MetroLink

Mater Railing Length and Green Space

Project No: 32108600
Document Title: Mater Railing Length and Green Space
Document No.: -
Revision: P01
Date: 2024/03/19
Client Name: Transport Infrastructure Ireland
Client No: -
Project Manager: Paul Brown
Author: Fergal Parlon
File Name: -

This note has been prepared in relation to the request for clarification on the linear meter of Existing Railing versus Railing Reinstated at Four Masters Park (Mater Station). Clarification was also sought on the Existing area of Central Green space (Central Grass Area) versus the proposed reinstated green space (Central Grass Area) in Four Masters Park. Figure 1.1 shows the alignment plan at Mater Station, which details the reinstatement of the railings at this location.

Figure 1.1: Mater Station Alignment Plan – Reinstatement of Railings and Green Space

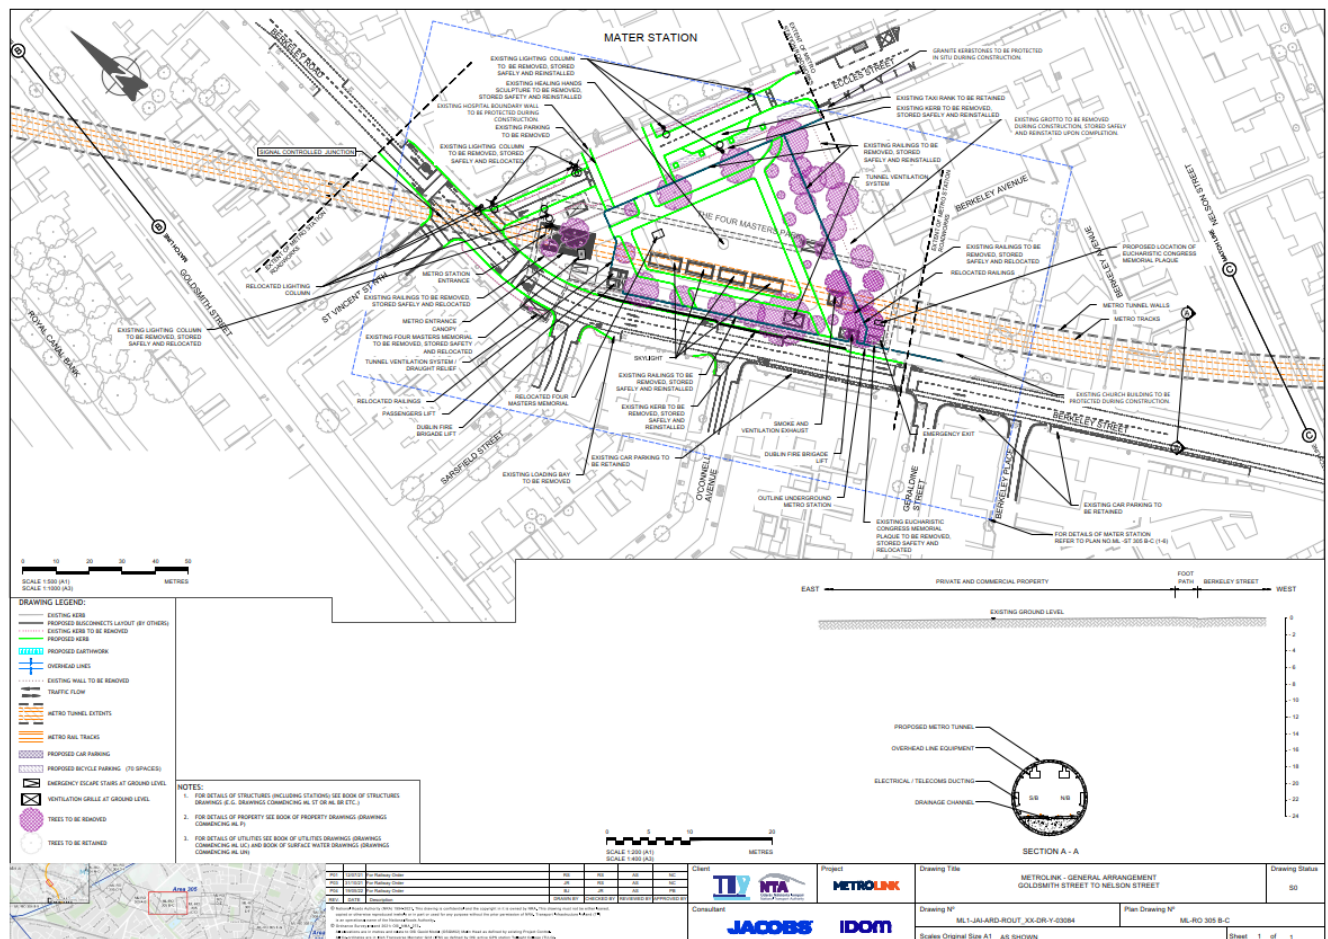
A query was raised in relation to the existing area of central green space (grass area) versus what is proposed to be reinstated in the central grass area.

- Existing Railing length at Four Masters Park location: 175m
- Proposed length of railing to be reinstated at the Four Masters Park: 165m

- Existing grass central area: 1050m²
- Proposed Grass central area: 780m²

The intricacy of the reinstatement means an increase in shrub planting in areas that are currently grass. Therefore, the above numbers relate to Central grass space only. There are a number of reasons for change from Grass to Shrub planting within the design, including reasons of biodiversity, design aesthetic, screening, circulation/navigation, and SUDs (Sustainable Drainage).

- Proposed shrub area within the Four Masters Park: 1290m²
